**RE: Dutch Brothers – San Antonio
7330 San Antonio Dr NE
Grading & Drainage Plan
Engineer's Stamp Date: 08/07/24
Hydrology File: E19D025C2**

RE: Responses to Grading and Drainage Comments
Dutch Bros Coffee (NM0504)
7330 San Antonio Drive Northeast, Albuquerque, New Mexico
City File No. E19D025C2 / Our Job No. 23204

DUTCH BROS COFFEE - NM0504, ALBUQUERQUE, NM 7330 SAN ANTONIO DRIVE N.E. GRADING AND DRAINAGE PLAN

C3-0G

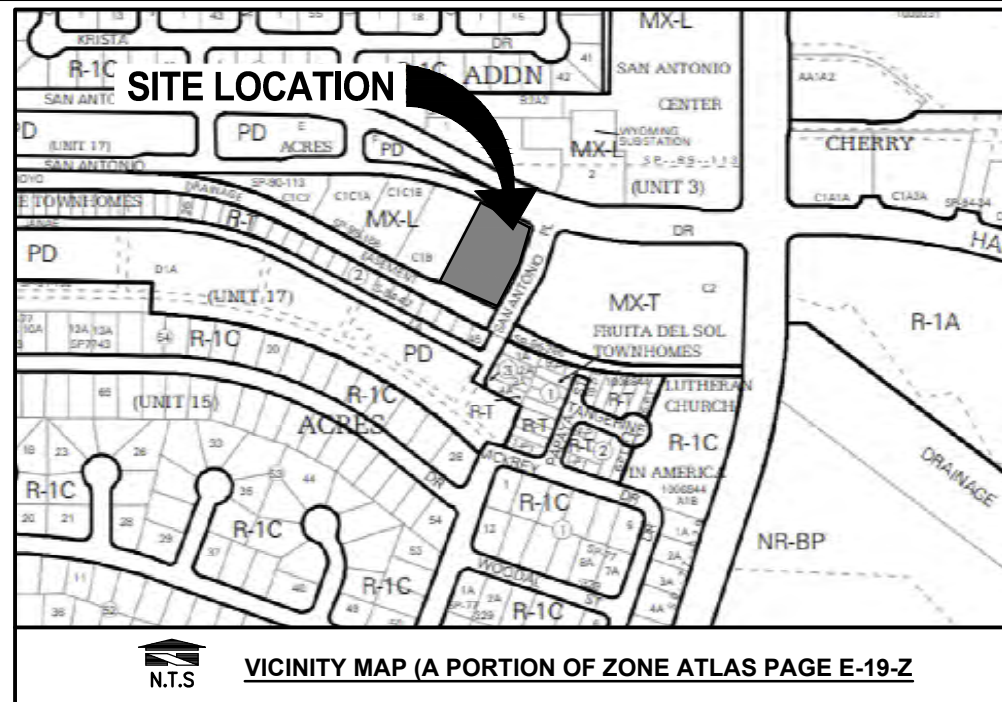
2. *Most of this information was provided on the Cover Sheet. However, per the DPM the following must be on the Grading Plan. Please note the Grading Plan must be a stand-alone construction document.*
 - a. *Please provide a Vicinity Map. Typically, this is the Zone Atlas. This can be downloaded in pdf format from the City of Albuquerque's website.*

- b. *Please provide the Benchmark information (location, description and elevation) for the survey contour information provided.*

- c. *Please provide the FIRM Map and flood plain note with effective date. This can be just a note if space is limited.*

- d. *Please provide a legal Description of the property.*

4. *Please use the procedure for 40 acre and smaller basins as outlined in Development Process Manual (DPM) Article 6-2(a). Please provide both the existing conditions and proposed conditions for the 100 year-6 hour storm event.*

5. *Please follow the DPM Article 6-12 Stormwater Quality and Low-Impact Development for the sizing calculations. To calculate the required SWQV, multiply the impervious area by 0.26 inches for redevelopment sites.*

6. *For trash enclosures serving food service developments, trash enclosures must demonstrate control of liquids from dumpster areas per DPM by containing runoff from the dumpster area, preventing outside drainage from entering the dumpster area, and discharging to the sanitary sewer. Please show an inlet in the middle and label. "Inlet to be connected to the sanitary sewer. See Utility Plan." This is shown but not labeled.*

Response: The vicinity map has been added to the Conceptual Grading and Drainage Plan, per your instruction.

Response: Benchmark has been added to the bottom left of the Conceptual Grading and Drainage Plan, per your instruction.

Response: Flood Zone Note has been added to the bottom left of the Conceptual Grading and Drainage Plan in lieu of a separate sheet, per your instruction.

Response: Legal Description of the property has been added to the Conceptual Grading and Drainage Plan, per your instruction.

Response: Please see the calculations included on the Conceptual Grading and Drainage Plan, utilizing the DPM.

Response: Please see the calculations included on the Conceptual Grading and Drainage Plan. Fee has also been calculated at \$8/CF per your direction and the DPM methodology.

Response: See added Keynote 14 on the Conceptual Grading and Drainage Plan.
